Memorandum

DATE: July 10, 2007
TO: Project Management Team
FROM: Carl Springer, PE; Colette Snuffin, PE

SUBJECT: Task 4: Technical Memo #5 – 10th Street Concept Plan (DRAFT) P06246-000

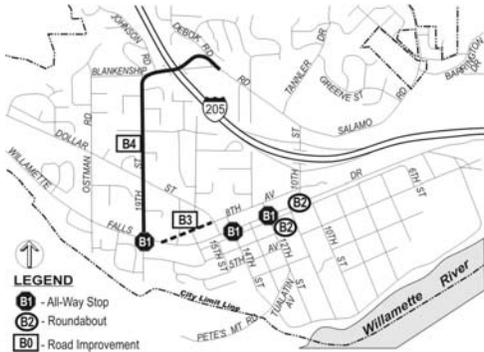
Comment [cts7]: check that #s of projects are correct and that none were left out – had a hard time following powerpoint slides – danella has redlines to revise graphics

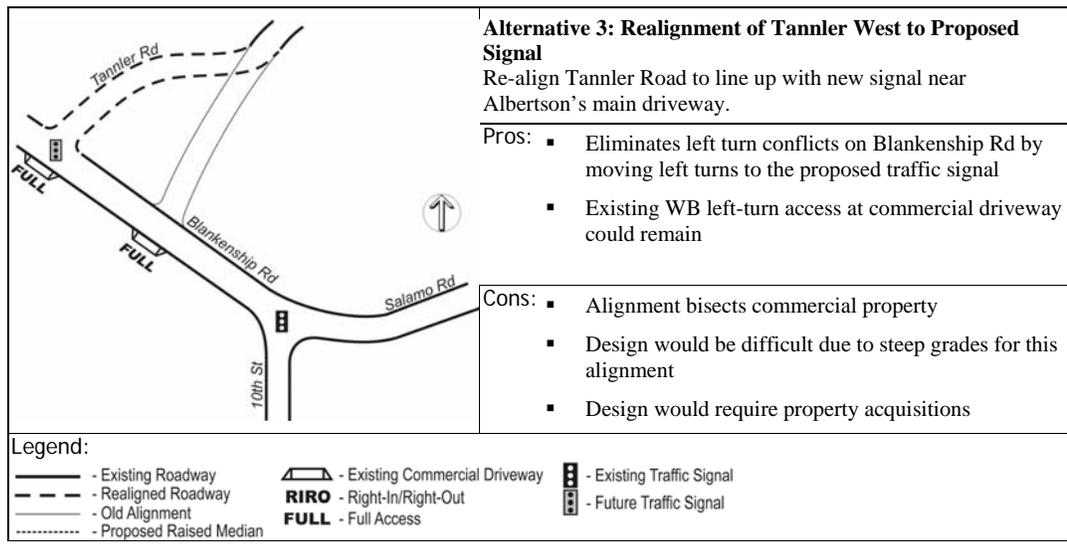
Comment [MSOffice9]: Properties adjacent to the proposed 8th Ct extension are all zoned General Commercial but are currently utilized in part as residential use.
